Memo

To: Plainfield Plan Commission
From: Scott Singleton, Director of Transportation
cc: Tim Belcher, Executive Director of Development Services
Andrew Klinger, Town Manager
Date: June 30, 2025
Re: PUD-25-015; PP-25-015
Transportation Comments on Westlyn PUD Re-Zone and Primary Plat

TRAFFIC IMPACT STUDY

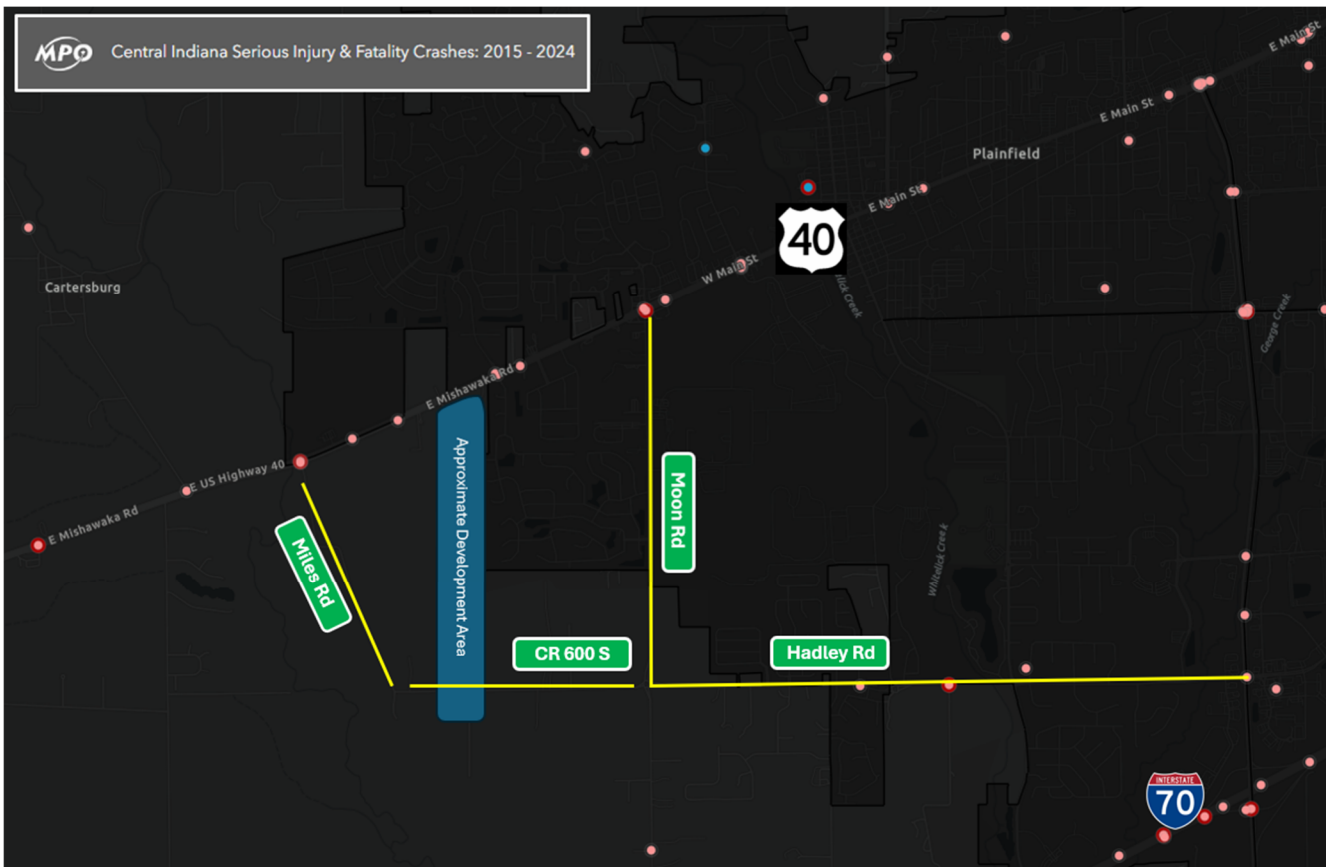
To iterate this point, note the below graphic shows a growth from 8,066 vehicles per day in 2007 to a recorded volume of 13,837 vehicles in 2019. These 5,771 v/d represent a 71.5% increase in just over 10 years. Past approvals for new neighborhoods along the Hadley-Moon Corridor and even up into Saratoga have contributed to this steady and significant increase.

Data collected in 2021 showed a notable dip that was the result of COVID lockdown and work-from-home situations. Since that time, the Town stopped collecting for the same data set. With traffic patterns normalizing over the past few years, these overall counts are expected to have increased.

A popular traffic engineering website (mikeontraffic.com) indicates a 2-lane roadway with left turn lanes has a capacity of approximately 18,300 adt (average daily traffic). Over these past 10 years, the Town has invested significant resources into Hadley and Moon Roads to provide the added capacity these left turn areas create, including the construction of several roundabout intersections. Thus, Hadley Road is operating at around 75% of its available capacity based upon the peak volumes recorded in 2019, but has likely moved beyond 80% given recent developments like Trescott under construction.

Adherence to Thoroughfare Plan

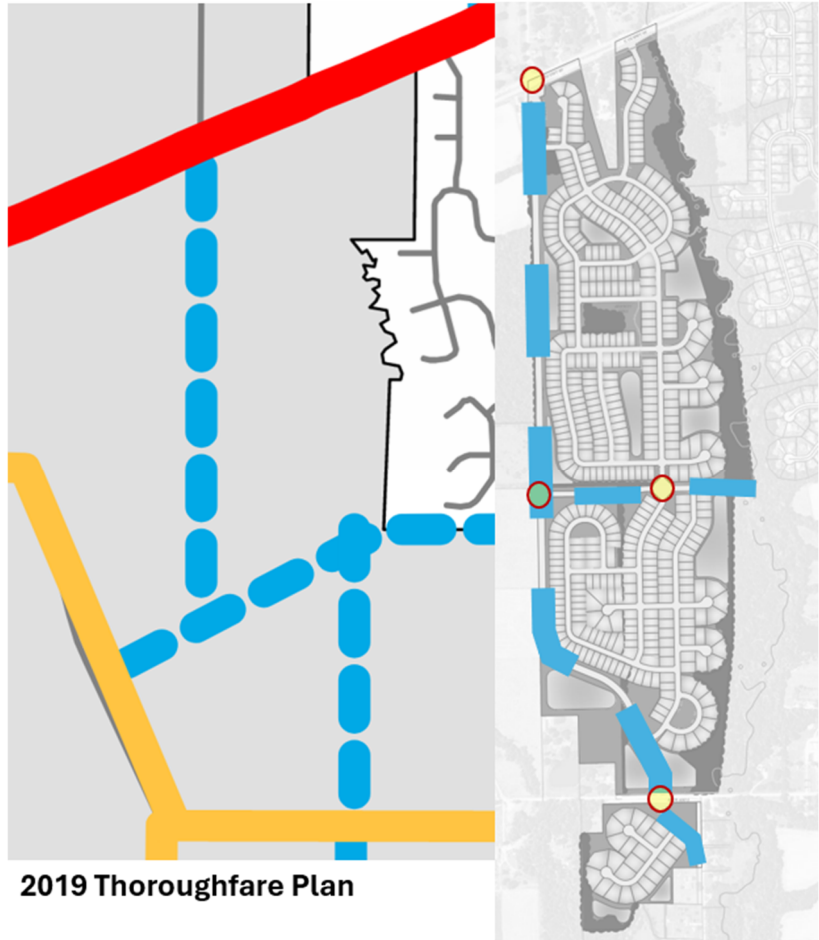
The Westlyn site plan has attempted to accommodate the Town's Thoroughfare Plan by incorporating Residential Collector's for needs to move local traffic both North & South and East & West through this area as it develops. Pulte has agreed to dedicate a full 70' width right-of-way from US 40 down to CR 600 S (aka Hadley Road). Similarly, a 60' width dedication for a future East/West route that is planned to connect to Moon Road in the future is being dedicated across the site. The development hasn't committed to building the entire infrastructure for these future roads, but is proposing to build sufficient distances to fully connect the neighborhood to both US 40 and CR 600 S. Remaining portions of the road would be expected to get built as other, nearby development occurs along an unknown timeline.

To better accommodate future intersection improvements that may be required as development happens, the Petitioner has also committed to dedicating additional property at key intersections to accommodate roundabout improvements.

A significant site layout decision has been to propose the realignment of CR 521 south of CR 600 S to a new location approximately 400' west of its current location. This will align with the new proposed North/South collector but will also serve to move those turning movements to an elevated location where sight distance is improved for drivers. Staff recommends vacating a portion of CR 521 from CR 600 S south to the new tie-in and Pulte is agreeable to coordinate new driveway connections for affected properties. Generally, this approach will increase front and side yards for existing properties that are affected by this change. Staff has discussed this change with the County Engineer who has offered informal support for this approach.
